- A. Rocker Arm Stud Replacement-MCM and MIE 110-120-140 (4 & 6-Cyl.)-150-160-165-190-200-225-250-270 and 310 Only
- B. Water Inlet Hose Retaining Clip - MerCruiser 888
- C. Tachometer Exchange - MCM 888 and MCM-MIE 215 Engines Equipped with Radio Shielding

Figure 1. Retainer Clip Position

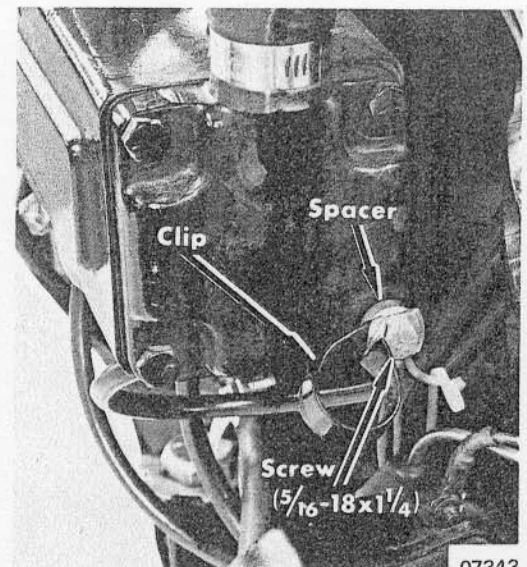
To prevent the water inlet hose from chaffing on the alternator, a retaining clip must be installed on all MerCruiser 888 engines between Serial No. 3322531 and 3344827. When installing or servicing one of these engines, install the clip as follows:

1. Remove water inlet line from thermostat housing.
2. Remove and discard lower right hand manifold end cap screw.
3. Attach retaining clip to manifold end cap with new screw (5/16-18x1 1/4"), placing spacer between clip and end cap.
4. Bend clip to position shown in Figure 1.
5. Thread hose thru clip and attach to thermostat housing. Secure with hose clamp.
